**Model  
Error Resolution Document**

| 1. Document Number: | MDL-NBS-HS-0000019 | 2. Revision/Addendum: | REV 01<br>AD 01 | 3. ERD: | 02 |

4. Title: Abstraction of Drift Seepage

**CR 12414:** This CR was initiated because *Abstraction of Drift Seepage* (MDL-NBS-HS-000019 REV 01 AD 01 [DIRS 181244]) includes text and schematic drawings that have probabilities of greater than 1.0. The CR describes text and figure changes that are to be made to the AMR and the SAR. This ERD is prepared to make the changes described in CR 12414.

Figure 6.6-2. Histogram and Related Probability Distribution for Spatial Variability of Capillary-Strength Parameter  $1/\alpha$ , Using Statistical Parameters Based on Method A

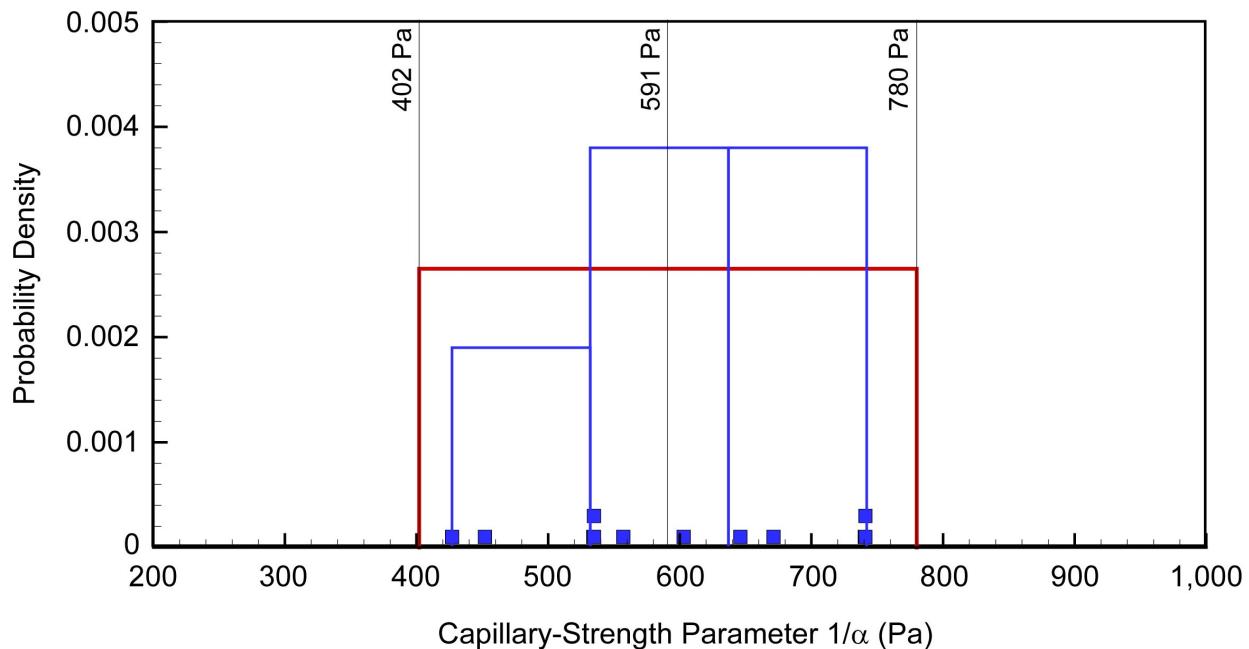
Figure 6.6-2 on pg. 6-113 of *Abstraction to Drift Seepage* (MDL-NBS-HS-000019 REV 01 AD 01 [DIRS 181244]), appears to be correct, however, the y-axis label needs to be updated as the data contained thereon is also based on probability density. Figure 6.6-2 is to be replaced with the figure shown below.

Figure 6.6-3. Schematic Showing the Triangular Probability Distribution (Blue Line) for Covering Uncertainty of the Capillary-Strength Parameter by Varying the Mean of the Spatial Probability Distribution, Using Statistical Parameters Based on Method A

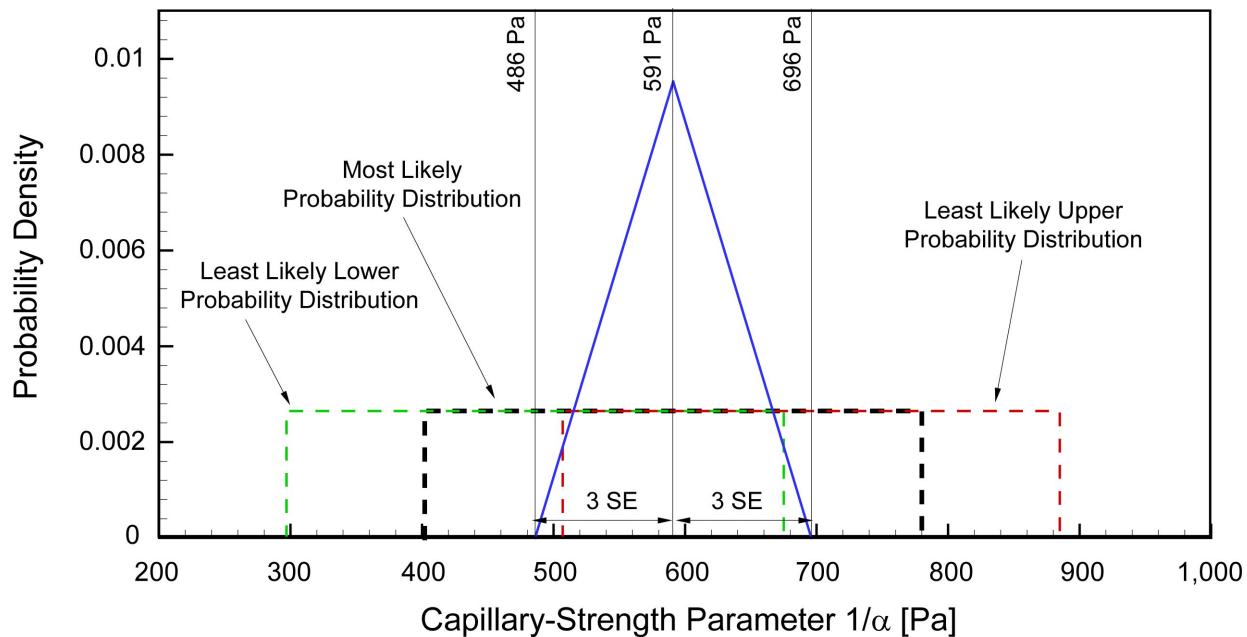
Figure 6.6-3 on pg. 6-116 of *Abstraction to Drift Seepage* (MDL-NBS-HS-000019 REV 01 AD 01 [DIRS 181244]), appears to be correct, however, the y-axis label needs to be updated as the data contained thereon is also based on probability density. Figure 6.6-3 is to be replaced with the figure shown below.

Figure 6.6-7. Schematic Showing Triangular Probability Distribution (Blue Line) for Covering Uncertainty of Permeability in the Tptpmn Unit by Varying the Mean of the Spatial Probability Distribution

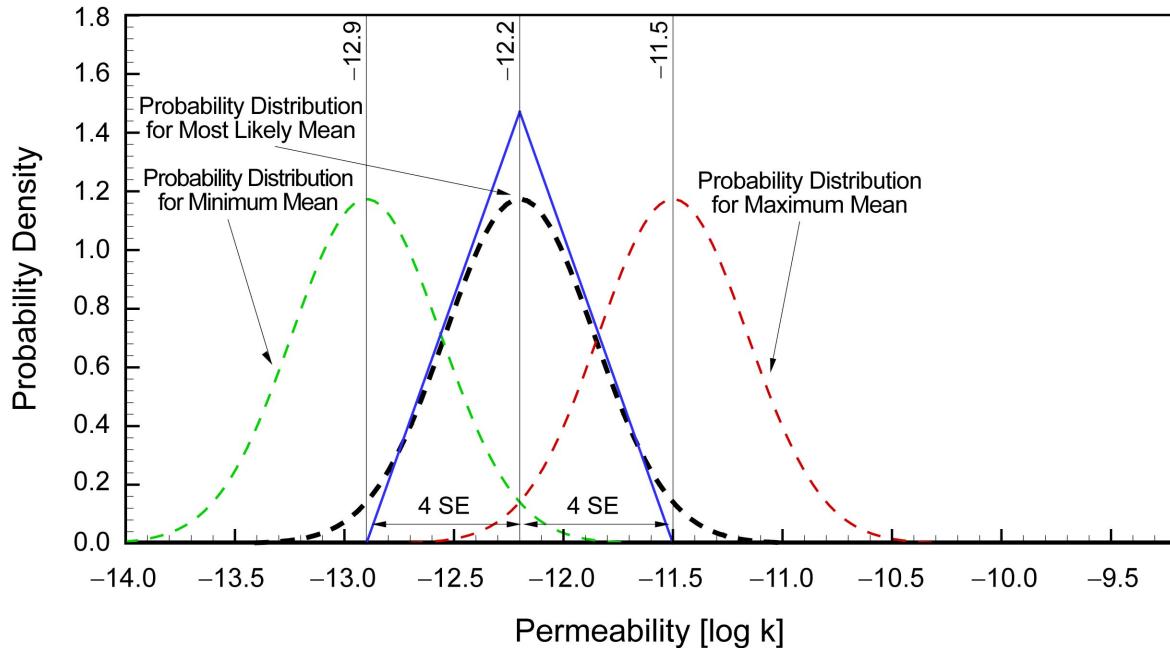
Figure 6.6-7 on page 6-136 of *Abstraction to Drift Seepage* (MDL-NBS-HS-000019 REV 01 AD 01 [DIRS 181244]) also needs correction to the y-axis label. Figure 6.6-7 is to be replaced with the figure below.

Figure 6.6-8. Schematic Showing Triangular Probability Distribution (Blue Line) for Covering Uncertainty of Permeability in the Tptll Unit by Varying the Mean of the Spatial Probability Distribution

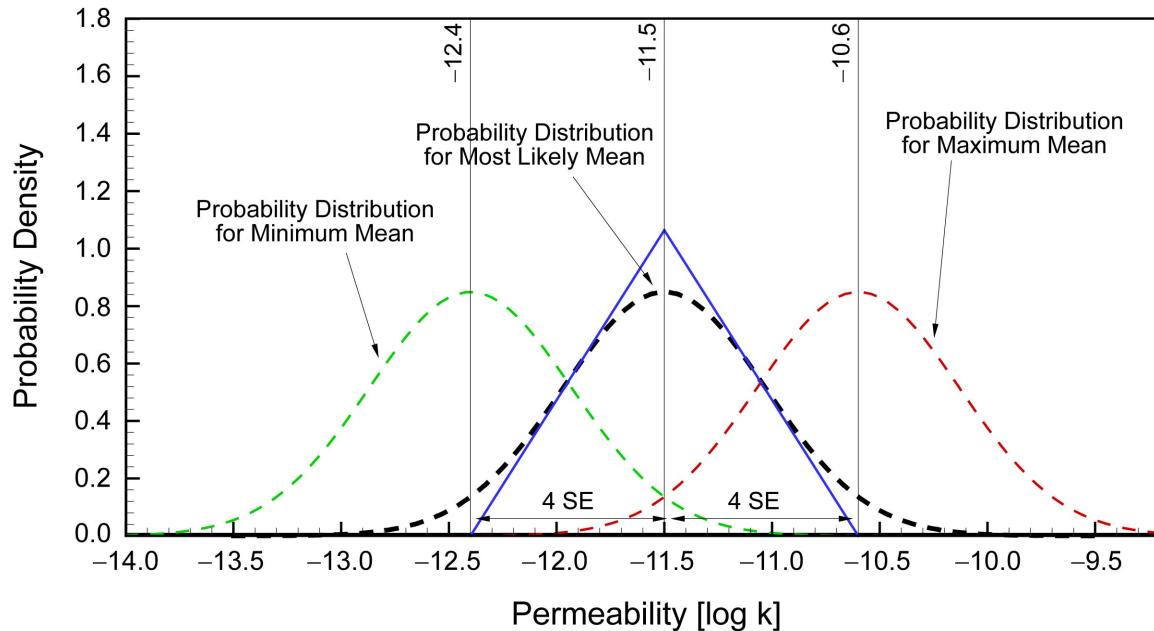
Figure 6.6-8 on pg. 6-137 of *Abstraction to Drift Seepage* (MDL-NBS-HS-000019 REV 01 AD 01 [DIRS 181244]) assigns a probability to the mean of the normal-shaped spatial variability distribution a value greater than 1.0. The data contained in this figure is based on probability density; therefore a change is needed to the y-axis label. Figure 6.6-8 is to be replaced with the figure shown below.
